INSPECTION REPORT
Sedimentation Structure
N14-M
Kayenta Mine
Navajo County, Arizona
for
PEABODY COAL COMPANY

Dames & Moore
10139-011-22

EXISTING
MAXIMUM CROSS-SECTION
A-A'
N14-M

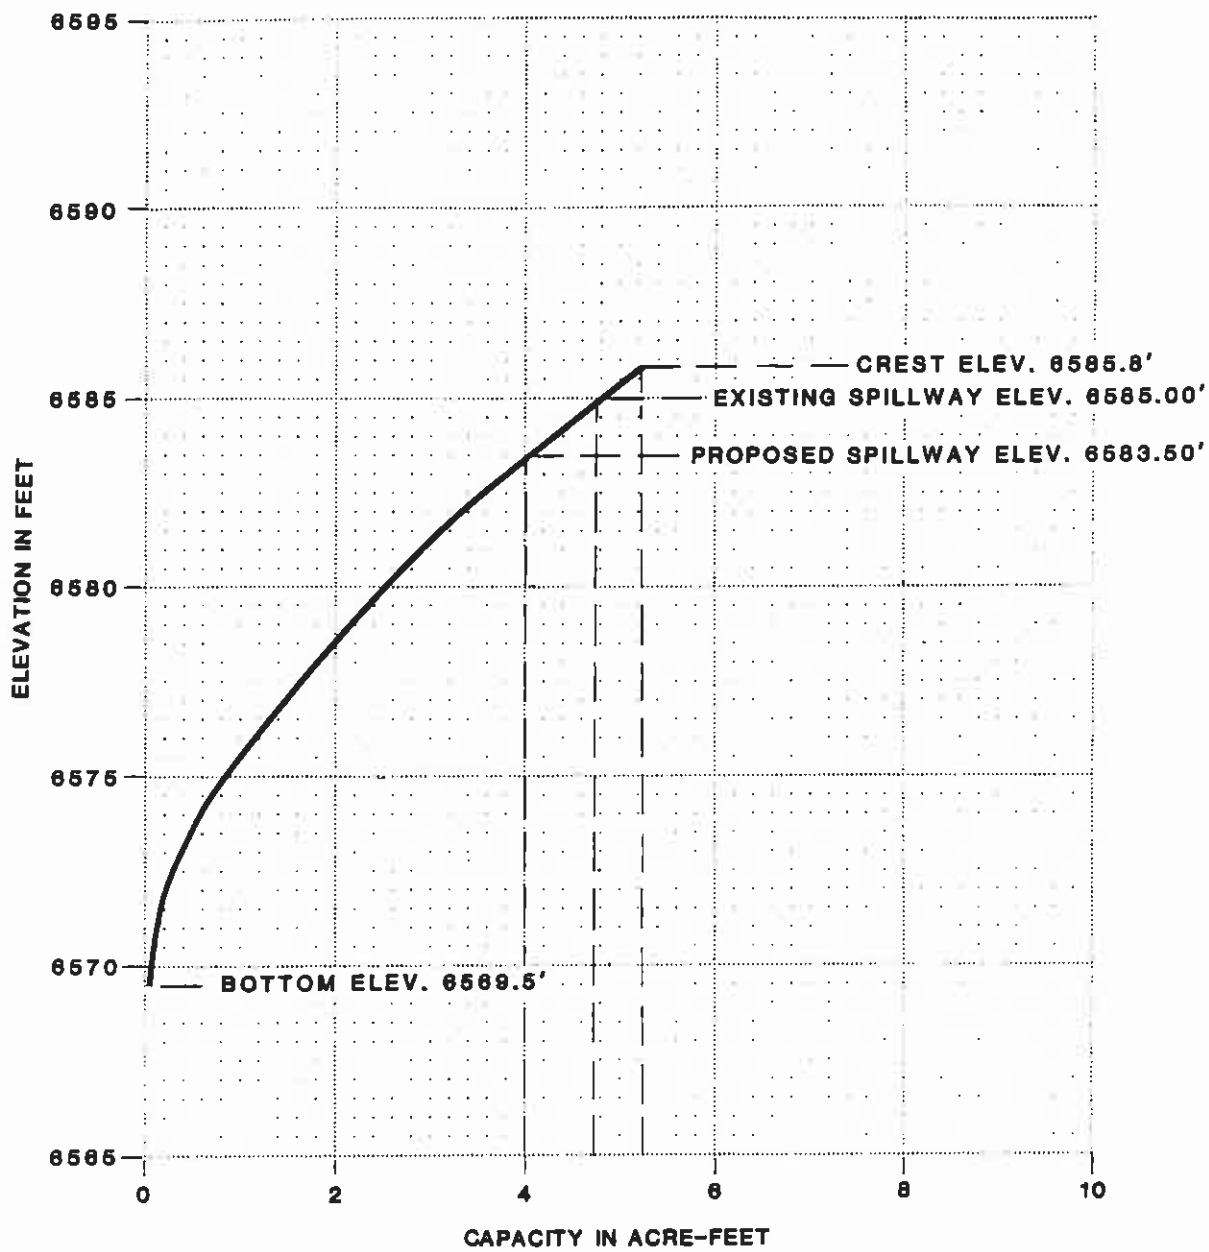
The downstream slope is lower in height and has a flatter slope than the category standard. The upstream slope is steeper than the category standard; therefore, the embankment has factors of safety less than the design minimum.

The inspection of Structure N14-M indicated that the only geotechnical problem is rill and gully erosion on the upstream slope, the side slopes of the outlet channel and the left abutment. Correction of erosion is considered a periodic maintenance task and does not require remedial action. The upstream slope should be flattened to 1.75 horizontal to 1 vertical to meet stability requirements.

CHANNEL PROFILE B-B'
N14-M

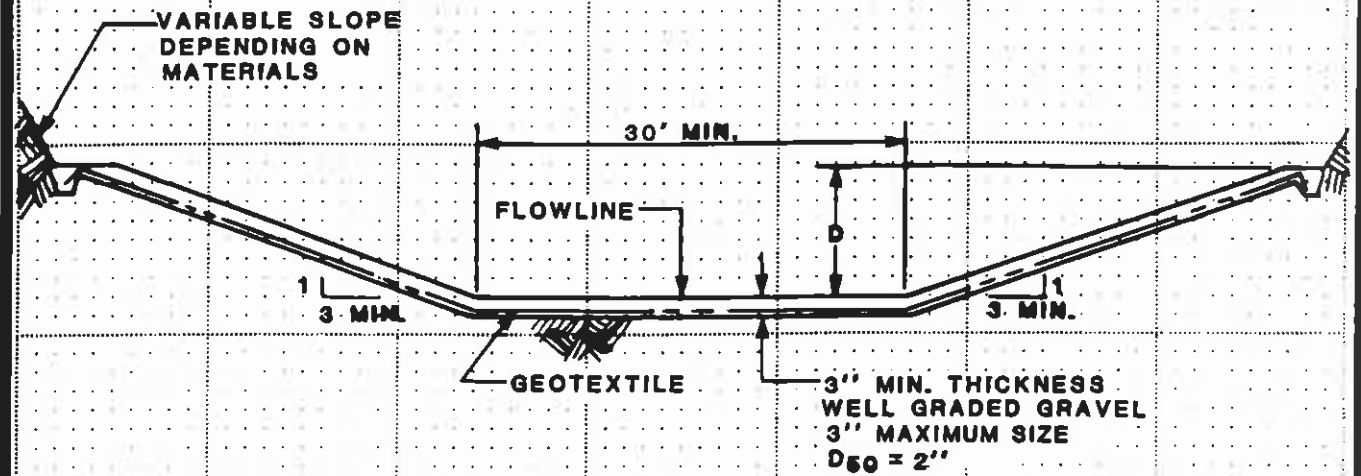
The storage capacity of Structure N14-M is adequate but the spillway capacity is inadequate. The structure does not have an adequate outflow channel. The bottom elevation of the existing spillway channel should be lowered to elevation 6583.5 feet and the bottom width increased to 30 feet as shown on Plate 5. A trapezoidal outflow channel with the same bottom width as the spillway should be constructed along the alignment shown in Plate 1. The channel profile is shown in Plate 4 and required dimensions are shown in Plate 5. Both the spillway and outflow channel should be protected against erosion using geotextile and gravel as shown in Plate 5.

SPILLWAY CHANNEL

D = 2.0'

LENGTH = 30'

FLOWLINE ELEV. = 6583.50'

OUTFLOW CHANNEL

D = 1.5'
